From: tricia.machon@gmail.com
Sent: Friday, 25 November 2022 11:49 AM
To: Council Northernbeaches Mailbox
Cc: Maxwell Duncan
Subject: DA2022/0653 1 Bellevue Parade, North Curl Curl

Fifth objection submission

DA2022/0653 1 Bellevue Parade, North Curl Curl

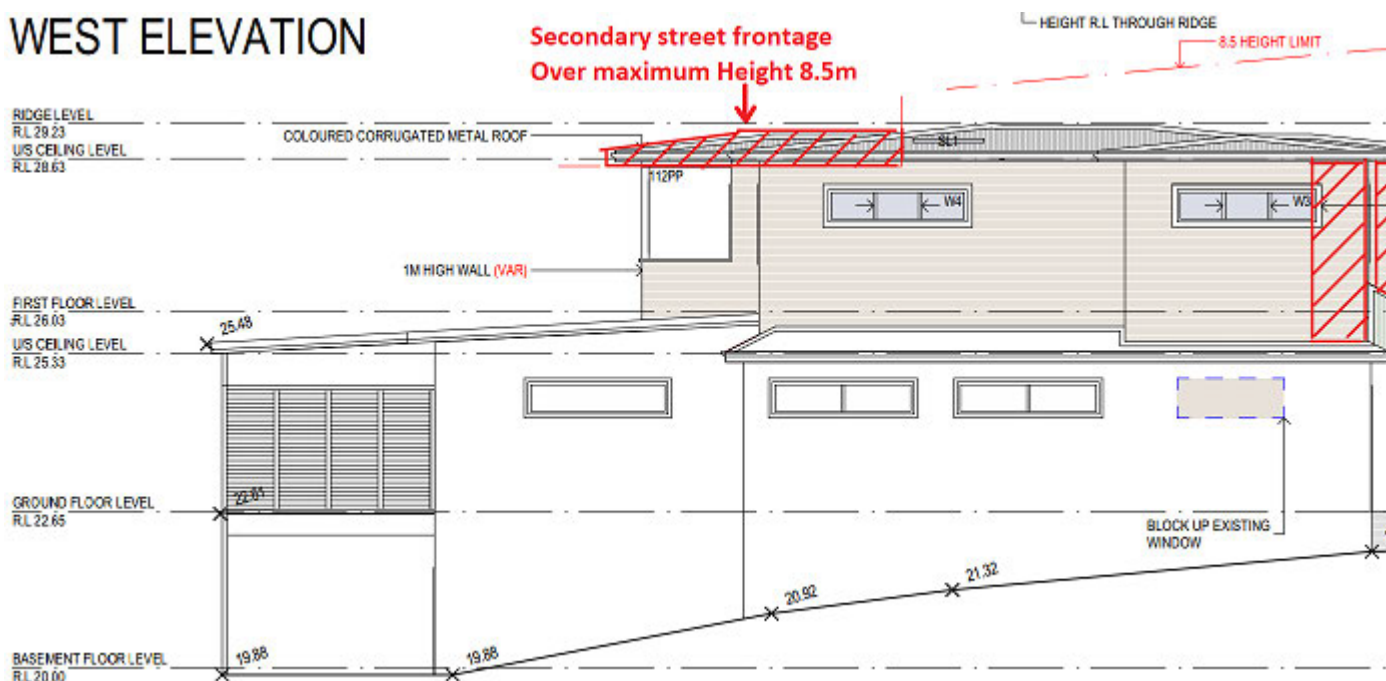
Objective 2 refers to “view sharing” stating that “to ensure and enhance local amenity by: facilitating view sharing”. The established view loss principles are set out in *Tenacity Consulting v Warringah* [2004] NSWLEC 140 (Tenacity) . The final amended Development Application still does not include the view sharing objectives of the DCP and Tenacity. No reasonable amendments have been applied to any of the amended DA’s. All concerns raised in all the objection submissions attached to DA2022/0653 relating to ocean view sharing have been ignored. The applicant had had ample opportunity to amend the DA to help “facilitate view sharing”. The photo shows the severe impact and the lack of view sharing.

Figure 31 - Side Setback Diagram

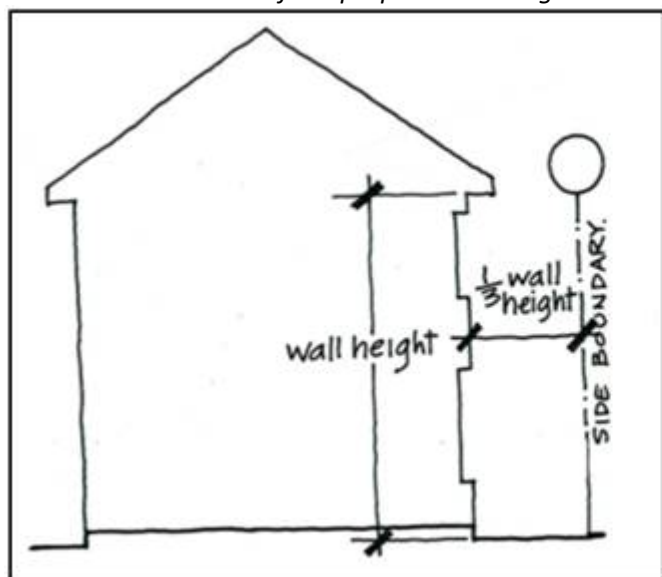
Section 4.1.4.2(a) Side Setbacks and Secondary Street Frontages states that “side boundary must not be less than one third of the height of the adjacent external wall”. Refer to Figure 31 – Side Setback Diagram above. The height of the eastern wall on the DA is 6,660mm. One third of the wall is 2,220mm. The minimum addition to the eastern side boundary has to be 2,220mm whereas the DA has it at 1050mm.

WEST ELEVATION

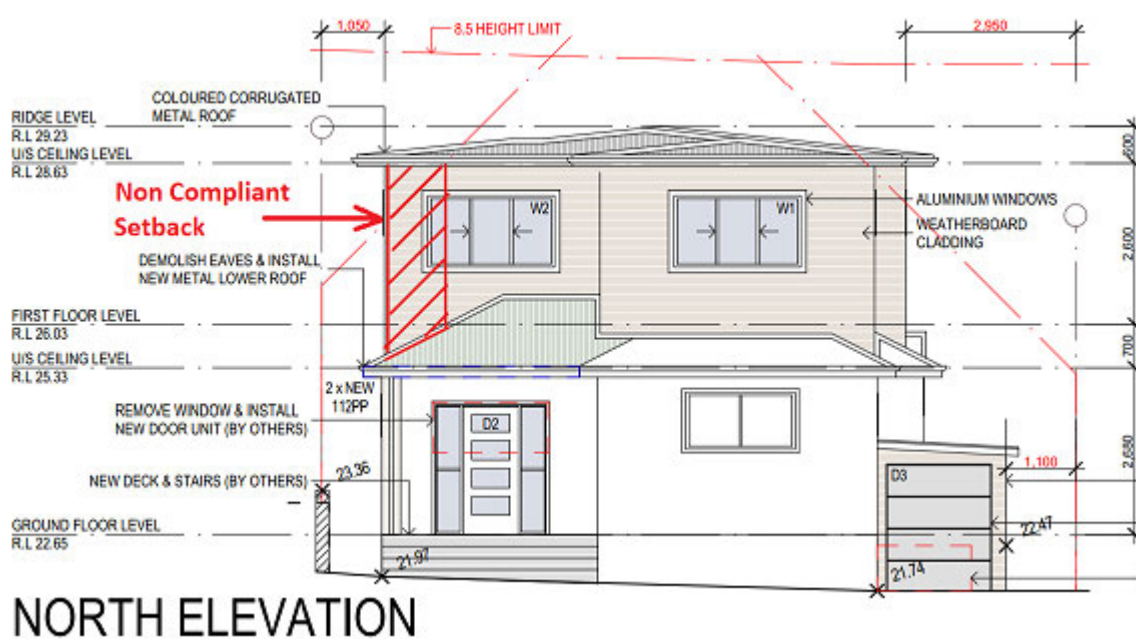
This highlights the non-compliance of the new addition with setbacks on the eastern and front boundaries in regards to the Setback rulings.

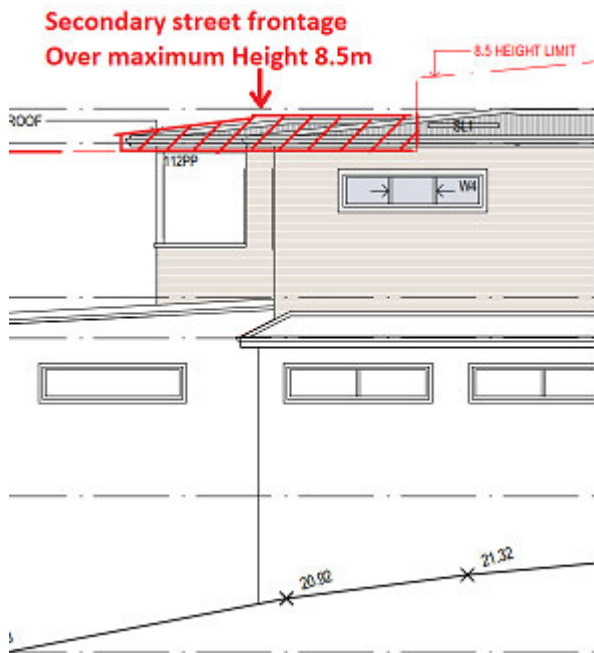
No 1 Bellevue Parade’s secondary frontage (eastern side of the house) will be visually bulky and impacting the streetscapes. The complete non-complying structure of the proposed development will be viewed from Bellevue Place. It must comply with the setback rules and height restrictions. Therefore the 8.5m maximum height limit must apply to the full roof line. The roof height of 9m, which extends more than a third of the house, does not comply with the maximum height limit of 8.5m.
